**CITY OF TEMPE
DEVELOPMENT REVIEW COMMISSION**

**Meeting Date: 04/28/2015
Agenda Item: 3**

ACTION: Request for a Development Plan Review for building elevations, site plan and landscape plan, and a Use Permit Standard for an increase in building height from 30 to 33 feet, consisting of 15 single family attached townhomes for THE BLOCK ON ROOSEVELT, located at 233 South Roosevelt Street. The applicant is Scott Garvin of Intent Development Advisors.

BACKGROUND INFORMATION: THE BLOCK ON ROOSEVELT (PL140336) is a multi-family residential through lot within the Riverside Neighborhood Association. The request includes the following:

SITE PLAN
 SCALE: 1/16" = 1'-0"

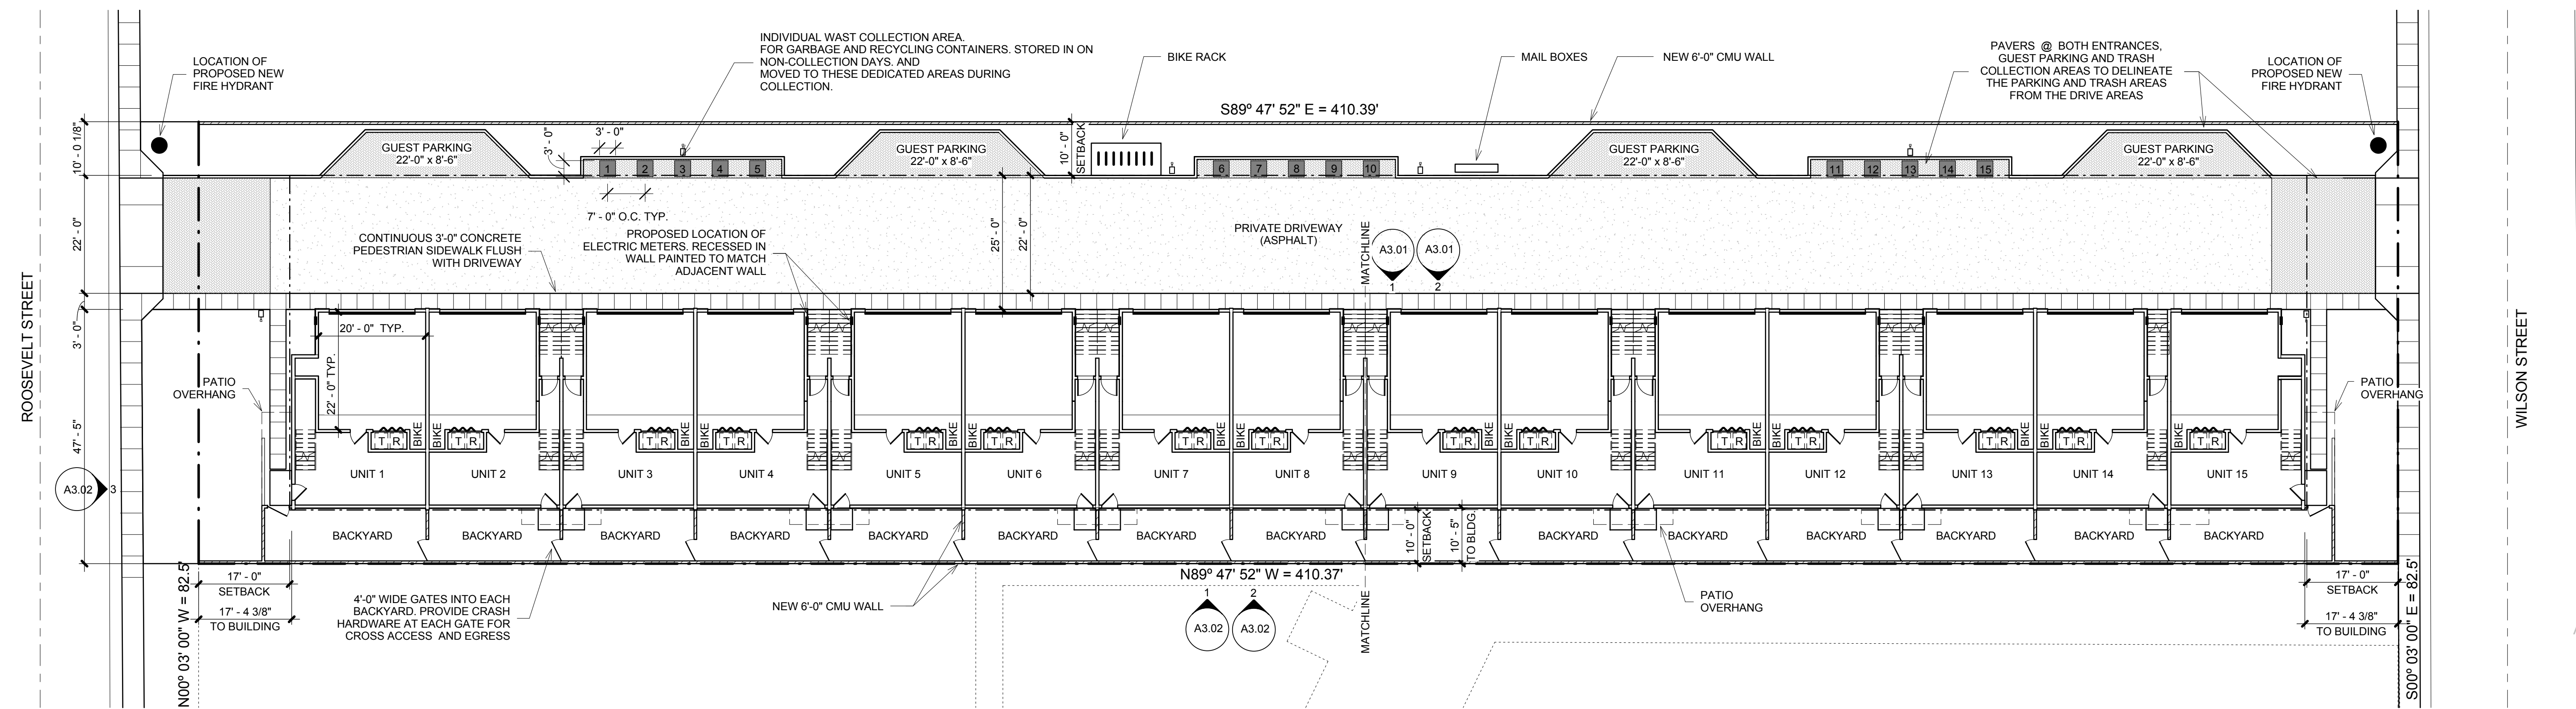
2. The site plan is approved as submitted (April 14, 2015), minor modifications may be reviewed through the plan check process of construction documents; major modifications will require submittal of a Development Plan Review.

3. Refuse and recycling containers shall be stored within the garages. On collection day, refuse containers must be placed on designated spaces identified by address and by change of surface material to assure adequate operational spacing for refuse collection.

- ENGINEERING:
 - Grading and Drainage Plans require dual-chamber retention wells (per prior Site Plan Review comments) not single-chamber as shown on plans.

- DRIVEWAYS:
 - Construct driveways in public right of way in conformance with Standard Detail T-320.
 - Correctly indicate clear vision triangles at both driveways on the site and landscape plans. Identify speed limits for adjacent streets at the site frontages. Begin sight triangle in driveways at point 15'-0" in back of face of curb. Consult Intersection Sight Distance memo, available from Traffic Engineering if needed www.tempe.gov/index.aspx?page=801. Do not locate site furnishings, screen walls or other visual obstructions over 2'-0" tall (except canopy trees are allowed) within each clear vision triangle.

LANDSCAPE PLAN

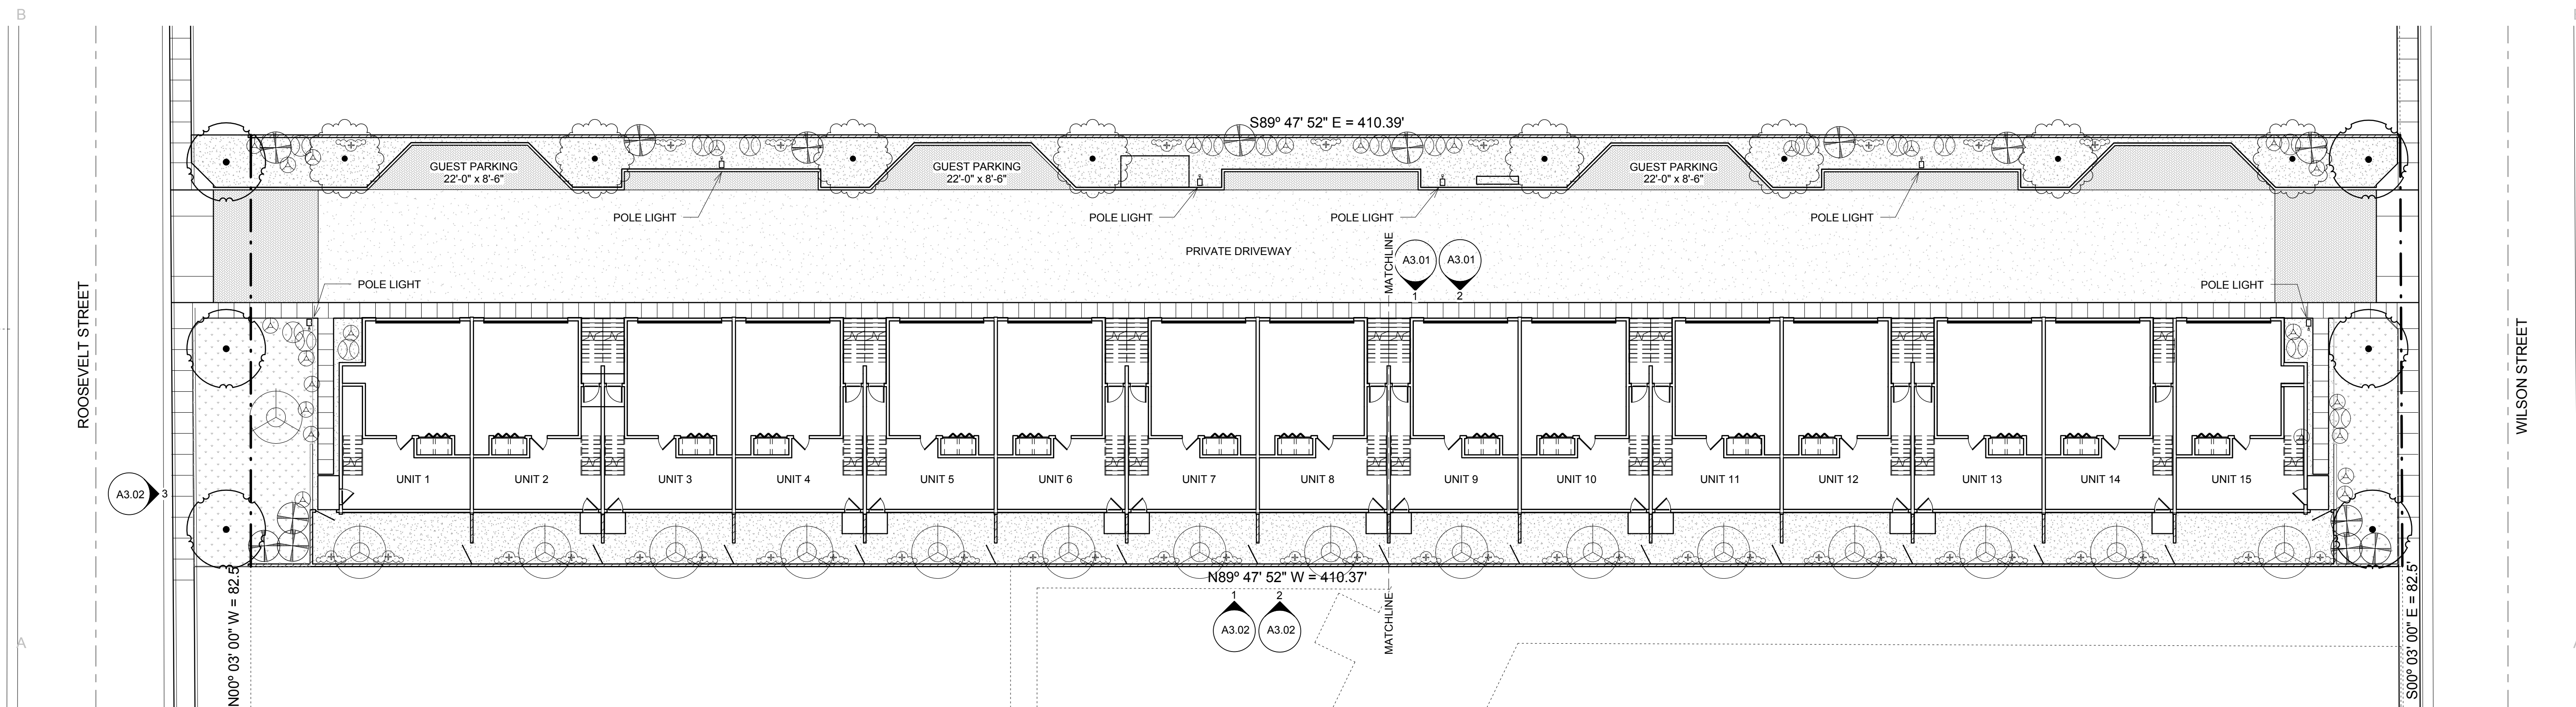
20. The plant palette is approved as proposed and specified on the landscape plan. An alternate tree species shall be provided for the south perimeter private yards, to provide a non-toxic patio tree variety as an option to residents. Any additions or modifications may be submitted for review during building plan check process.

24. Trees shall be planted a minimum of 20'-0" from any existing or proposed public water or sewer lines. The tree planting separation requirements may be reduced from the waterline upon the installation of a linear root barrier, a minimum of 6'-0" parallel from the waterline, or around the tree. The root barrier shall be a continuous material, a minimum of 0.08" thick, installed 0'-2" above finish grade to a depth of 8'-0" below grade. Final approval subject to determination by the Public Works, Water Utilities Division.
